**BOARD OF ZONING ADJUSTMENT  
STAFF REPORT****Date: December 5, 2011****CASE NUMBER**

5726

New Hope Baptist Church

**VARIANCE REQUEST**

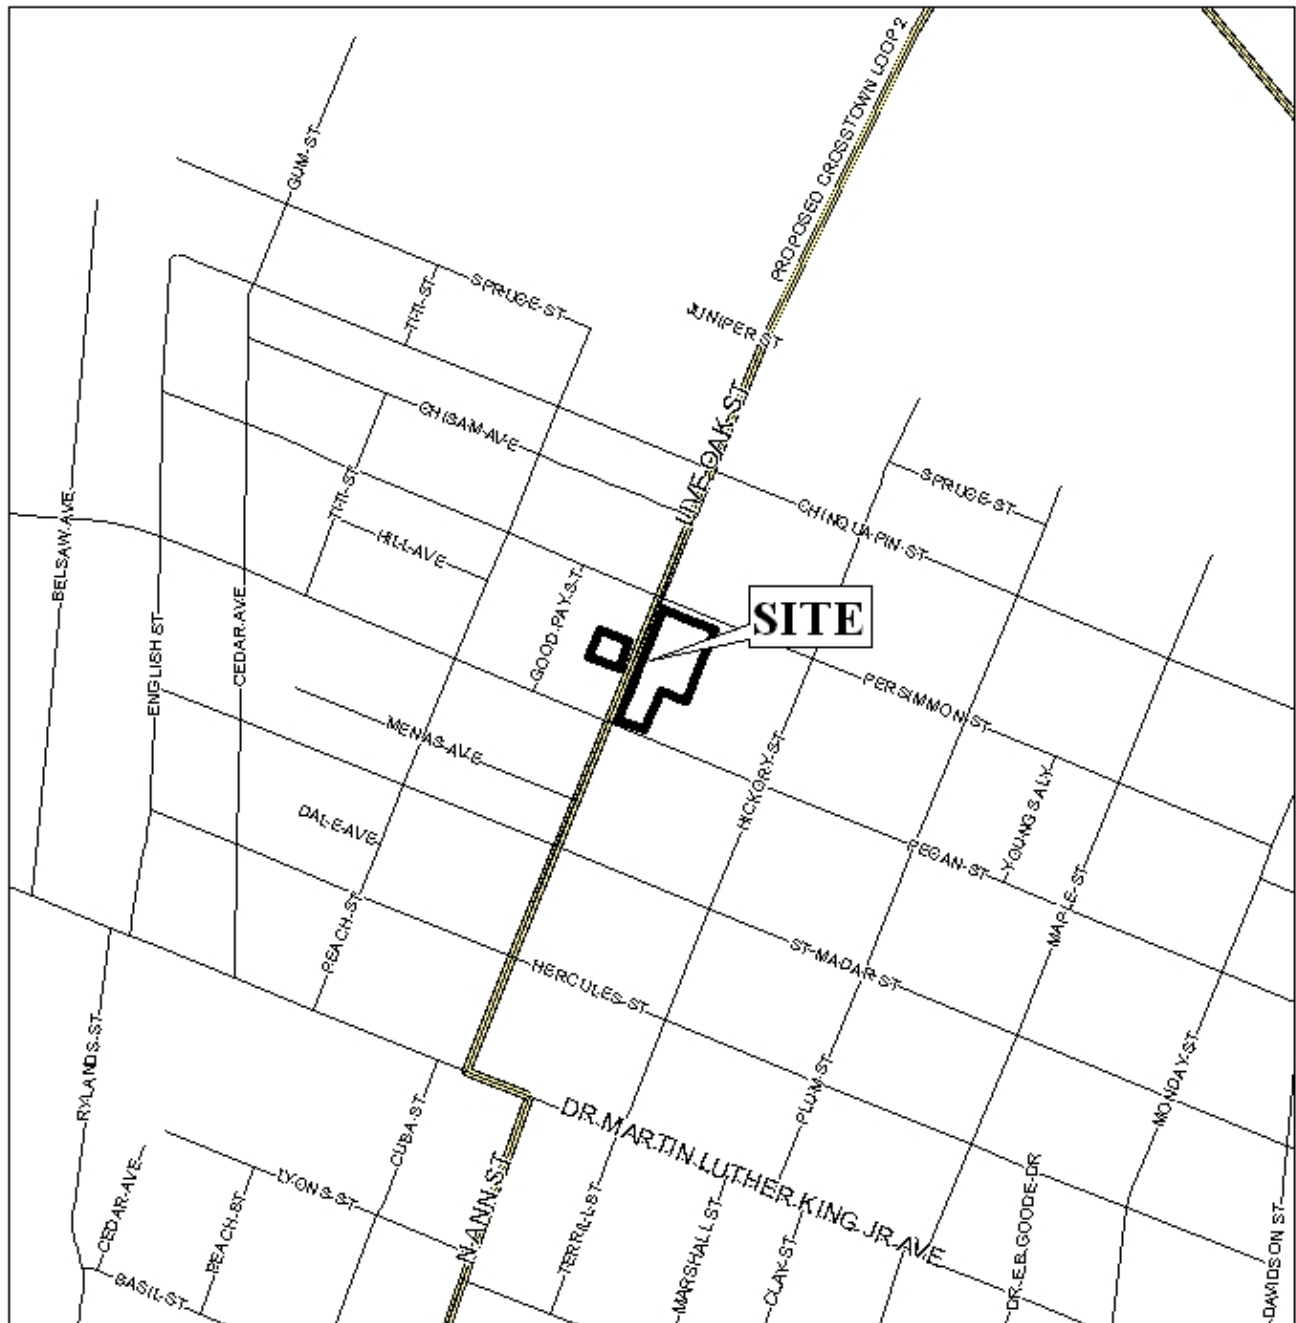
*The revised site plan now indicates compliance with frontage heritage tree planting requirements along both Pecan Street and Persimmon Street. Perimeter and Parking Lot tree plantings are also in compliance. Frontage heritage tree plantings are not in compliance along Live Oak Street. The Zoning Ordinance requires a total of ten (10) trees, and only four are provided.*

*The applicant states the remaining tree plantings are not practicable due to the reduced setback for the church building, both existing and proposed, as well as a required storm drainage pipe in the available green space area.*

*The issues described by the applicant are self-imposed, and thus, not a basis for granting a variance. Indeed, there is adequate area to plant the required trees, and the storm drainage pipe could be relocated so as to limit the tree root interaction.*

*Based upon the preceding, the application is recommended for denial.*

SITE PLAN

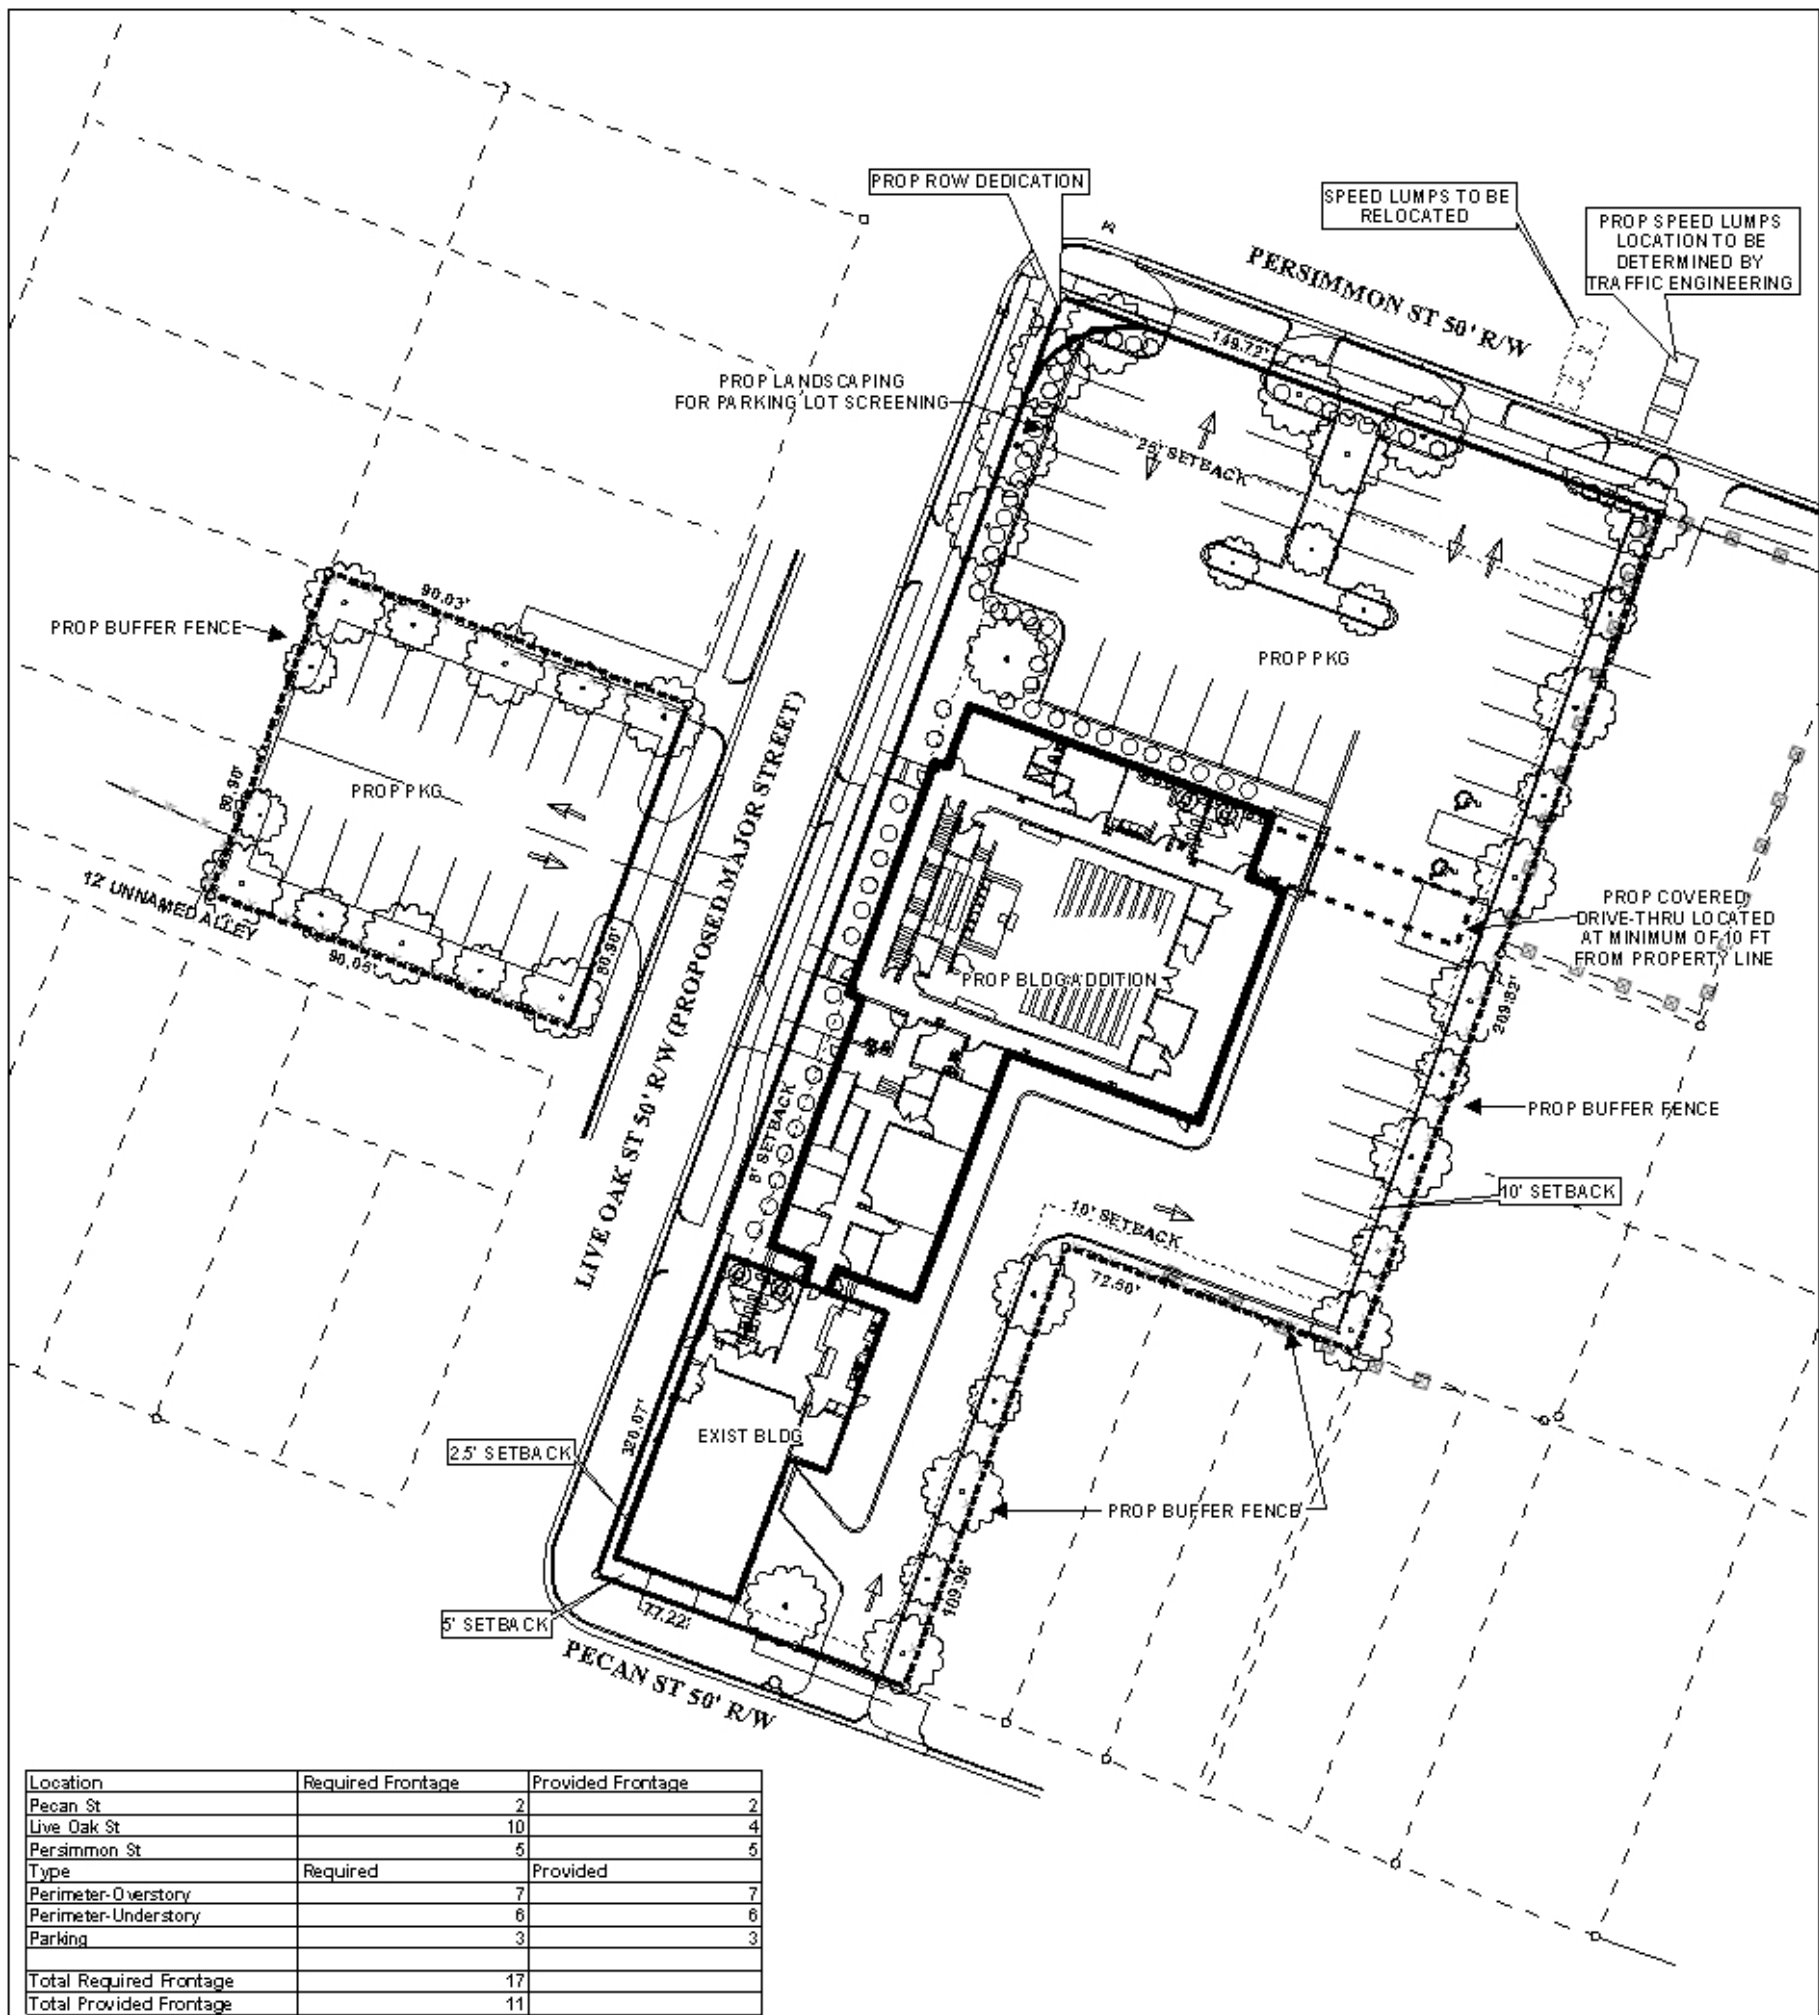
Along Live Oak Street, there is sufficient room to plant the required trees. The applicant is providing four (4) trees, and six (6) more are required. There is an 8.5-foot strip of land between the property line and the proposed building wall that is 140 feet long, which provides an area large enough that the six trees could be planted in. Although not stated in the narrative, the applicant has verbally stated that they do not believe the 8.5-foot wide strip would be adequate for Live Oak Trees (required due to overhead power lines). Live Oaks Trees have been planted with less space, and, indeed, Live Oaks are shown with less than 8.5-feet on the same plan. Regardless of that fact, the 8.5-foot limitation is based on the applicant's site plan, and, as mentioned by staff to the Planning Commission, it may mean that the site is being proposed for overdevelopment.

The potential overdevelopment issue is also apparent with the Pecan Street frontage. Due to the location of a required parking space, driveways, and the existing non-conforming church building, there is only one frontage tree proposed to be provided. Again, this lack of space is a function of the applicant's site plan, which may indicate that the site is being proposed for overdevelopment, and thus, any hardship would be self-imposed.

Based upon the preceding, the application is recommended for denial.
